Date: December 6, 2024

From: Emily Bothell, Senior Associate Transportation Planner

Re: Melrose Avenue and Koser Avenue/Golfview Avenue Intersection Analysis

Figure 4: Preliminary Exhibit – Melrose Avenue Complete Street Improvements

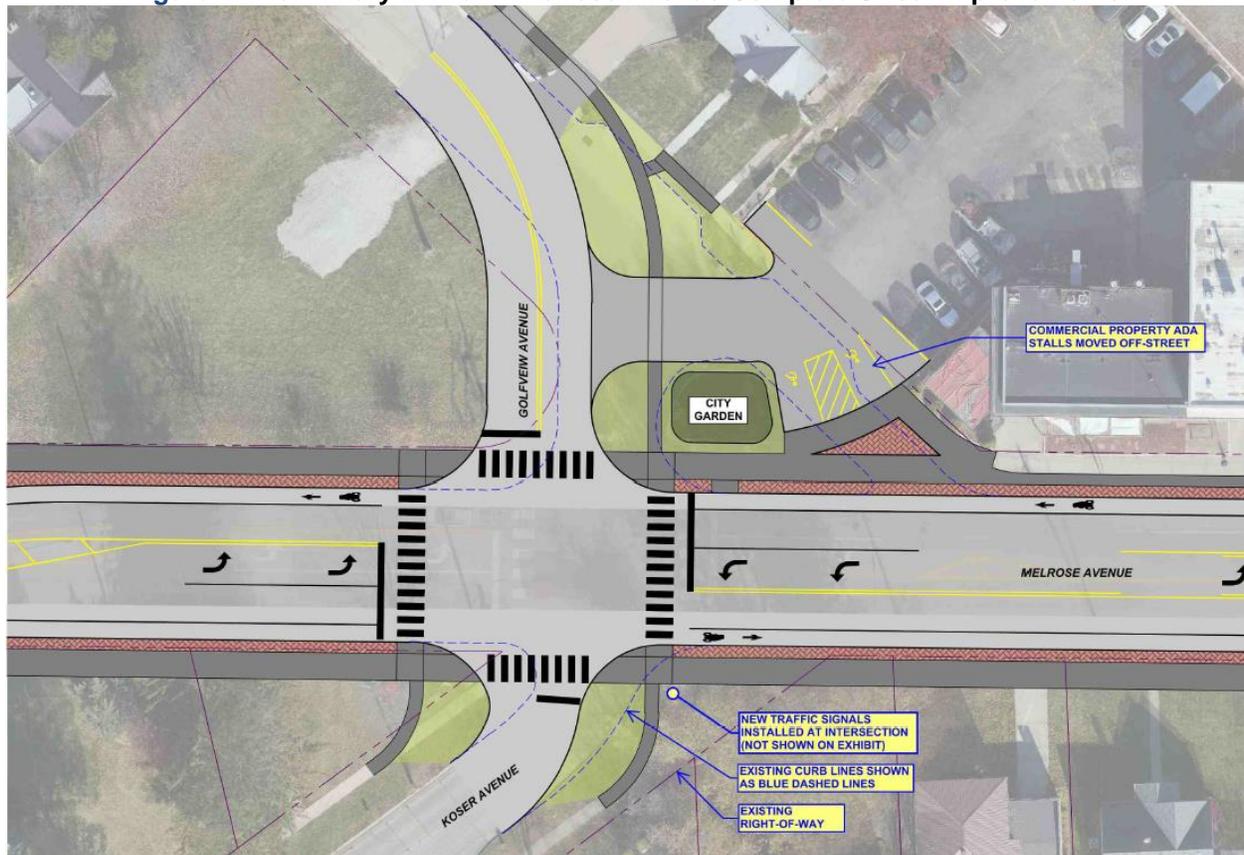
The preliminary design for the intersection of Melrose Avenue and Koser Avenue/Golfview Avenue is illustrated in **Figure 4**. The primary change to the intersection layout is the removal of the westbound right-turn slip lane located adjacent to 1000 Melrose Avenue. After reviewing the preliminary design, we find the redesign of the intersection to be positive and have compiled the following comments as requested:

1. The removal of the westbound right-turn slip lane slows motorists' turns and reduces the risk of pedestrian and bicycle collisions, and reduces the number of total pedestrian crossings.
2. The crosswalks are at right angles to the road, increasing the predictability and decreasing the distance of pedestrian crossings at the intersection.
3. Stop lines are clearly marked before the crosswalks, indicating where motorists should stop due to the high volume of pedestrians and bicyclists at the intersection.
4. Realigning the Golfview Avenue leg of the intersection across from Koser Avenue reduces the turning radius and should slow turning movements, enhancing pedestrian safety.
5. The intersection is accessible for all users: pedestrians, bicyclists, motor vehicles, and transit users.
